THE SECOND MEETING OF THE MUNICIPAL HERITAGE COMMITTEE

Heritage Alteration Permit – HAP-02-26 581 Talbot Street **Pages 2-22**

SUBJECT: Heritage Alteration Permit
581 Talbot Street
HAP-02-26

THE ATRIUM EXTERIOR RENOVATION

1 FRONT ELEVATION
ID300 SCALE: 3/16" = 1'-0"

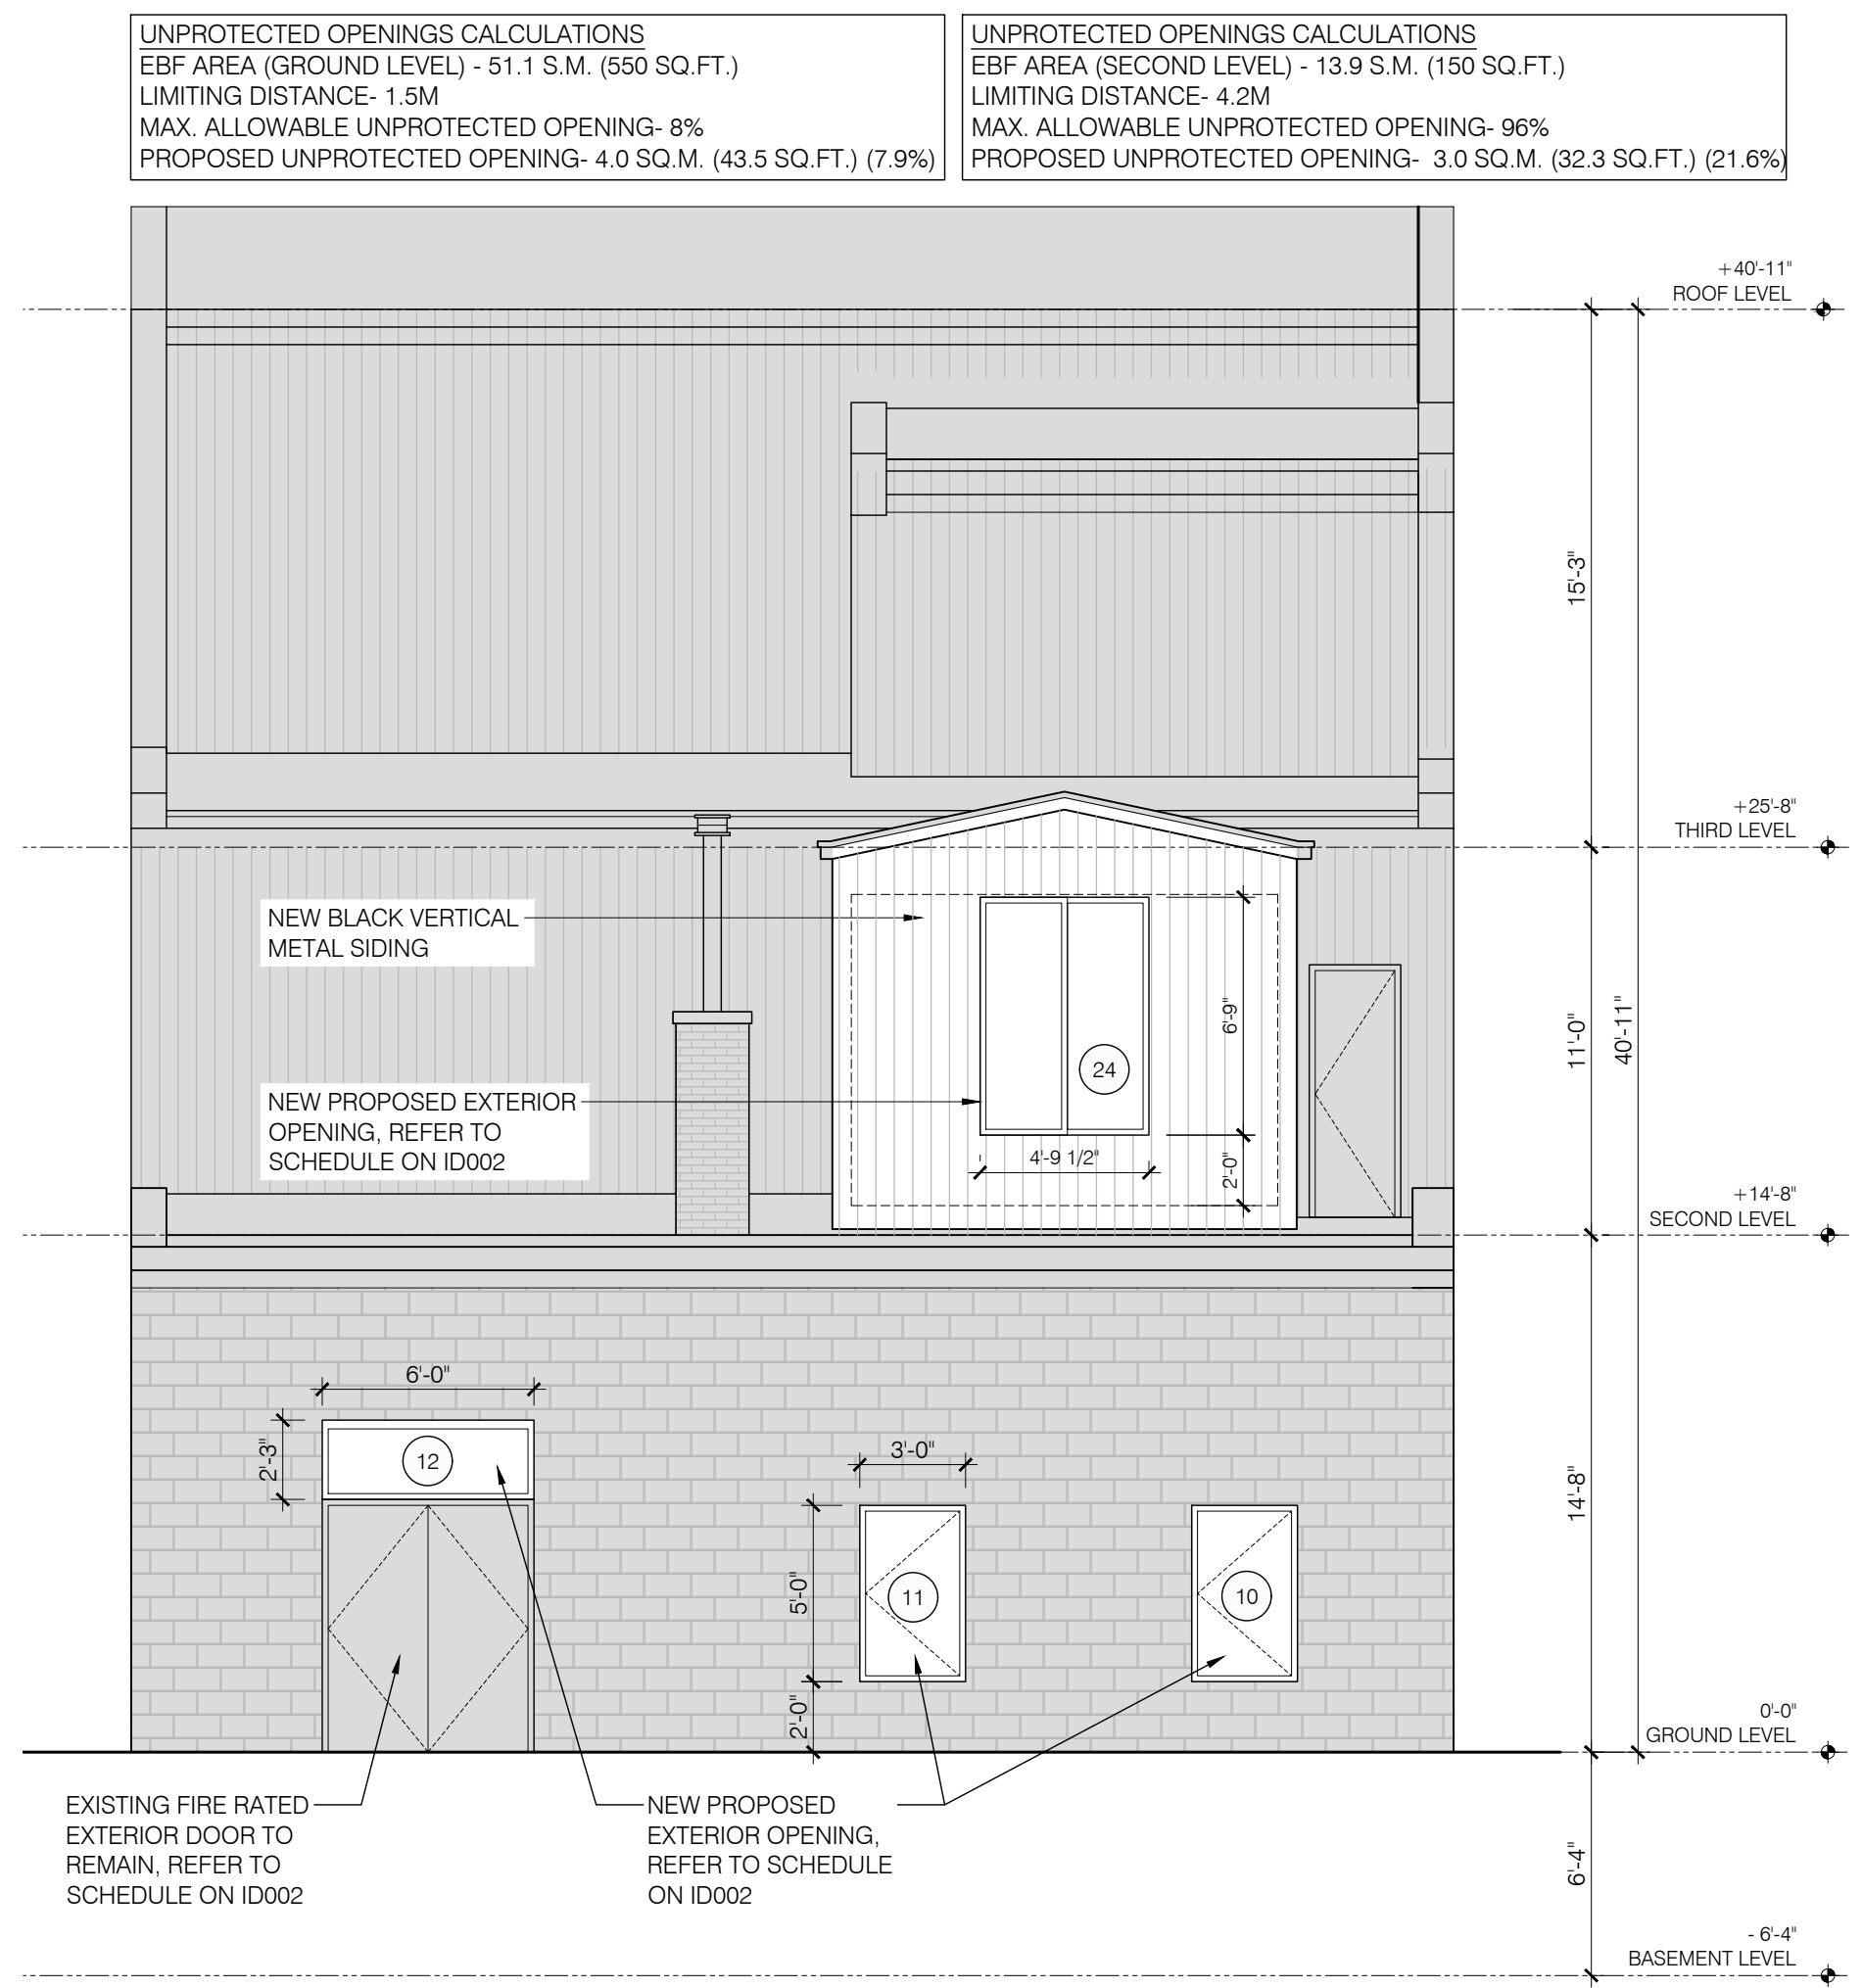
The applicant is looking to replace the existing second and third-storey windows on Talbot Street with new vinyl units. It is unclear what style of units are being proposed other than the colour would match the existing. Given the historical evidence of the property, it would be suggest that the new windows are single-hung units to be consistent with the policies of the HCD Plan.

Section 4.3.2.8 speaks to Signage and states *“avoid internally illuminated signs”*. The applicant has proposed an illuminated “halo” sign. The Committee will need to determine whether it would be supportive of this type of proposed signage versus other exterior lit signage options.

2 REAR ELEVATION
ID300 SCALE: 3/16" = 1'-0"

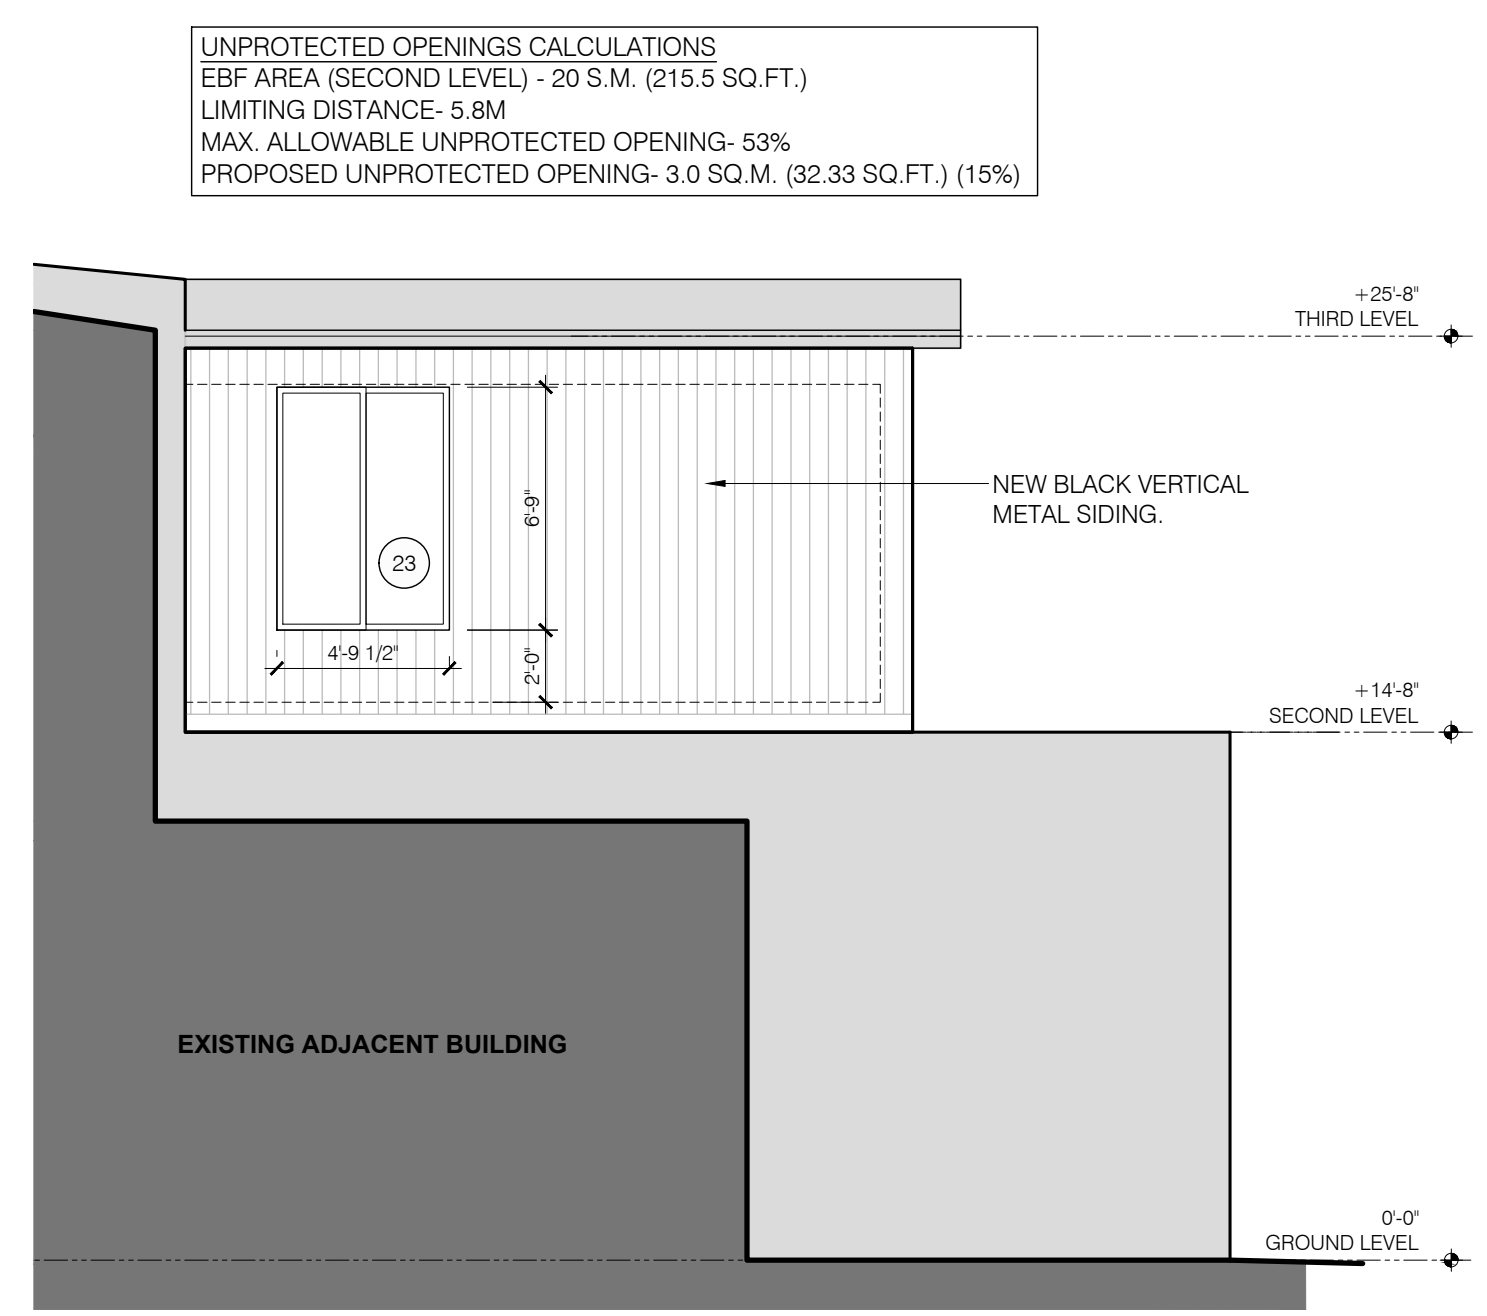
The applicant is looking to install new vertical metal siding on a rear portion of the building on the second floor and add new windows on the three sides. Further, three new windows are proposed at the rear of the building on the main floor.
